## **Access Compliance Report Public Rights-of-Way** (Curb Ramps)

Intersection ID: 27411 Main Street: BALLANTYNE\_COMMONS\_PY Cross Street: BALLANTYNE\_CORPORATE\_PL Location: NE

ADA ID: 40D9648A5A50 Ramp Type: Perp Initial Pass/Fail: Fail **Overall Compliance: No** Severity Score: 13.75

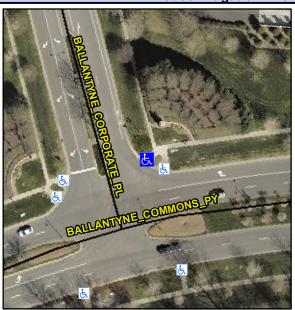
Ramp Slope (%)

Ramp XSlope (%)

N/A	Flare Slope LT (%)	N/A	N/A	Flare Slope RT (%)	N/A
					N/A	Flare Traversable LT?	N/A	N/A	Flare Traversable RT?	N/A
	(1) (1) (1) (1) (1) (1) (1) (1) (1) (1)				N/A	Landing Length (in)	N/A	N/A	DWS Provided?	N/A
		Surveyor Notes:			N/A	Landing Width (in)	N/A	N/A	DWS Contrast?	N/A
	E A	N/A			N/A	Landing Slope (%)	N/A	N/A	DWS Length (in)	N/A
6	6.				N/A	Landing X Slope (%)	N/A	N/A	DWS Full Width?	N/A
₽ E	~ PY				N/A	Landing Curb? (Y/N)	N/A	N/A	DWS Offset (in)	N/A
200	ANE COMMONS				N/A	Shared Landing?	N/A			
BALLANI	TAME COMMONS BY	PROW/ADA:			N/A	Gutter Ponding?	N/A	N/A	Gutter Slope (%)	N/A
		Not Found, R304.2.2, R304.	5.3		N/A	Gutter Lip Ht (in)	N/A	N/A	Gutter X Slope (%)	N/A

Possible Solutions:	Compli	ance	Description
Remove & Replace Entire Ramp.	N/A	Ram	p Length (in)
·	Yes	Ram	p Width (in)
	N/A	Flare	Type LT
	N/A	Flare	Slope LT (%)
	N/A	Flare	Traversable LT
	N/A	Land	ing Length (in)
Surveyor Notes:	N/A	Land	ing Width (in)
N/A	N/A	Land	ing Slope (%)
	N/A	Land	ing X Slope (%)
	N/A	Land	ing Curb? (Y/N)
	N/A	Shar	ed Landing?
PROW/ADA:	N/A	Gutte	er Ponding?
Not Found, R304.2.2, R304.5.3	N/A	Gutte	er Lip Ht (in)
	N/A	Paint	ed X Walk1?
		X Wa	lk 1 Direction
	N/A	X Wa	ılk 1 Width (in)
		X Wa	ılk 1 Slope (%)
		X Wa	ılk 1 X Slope (%
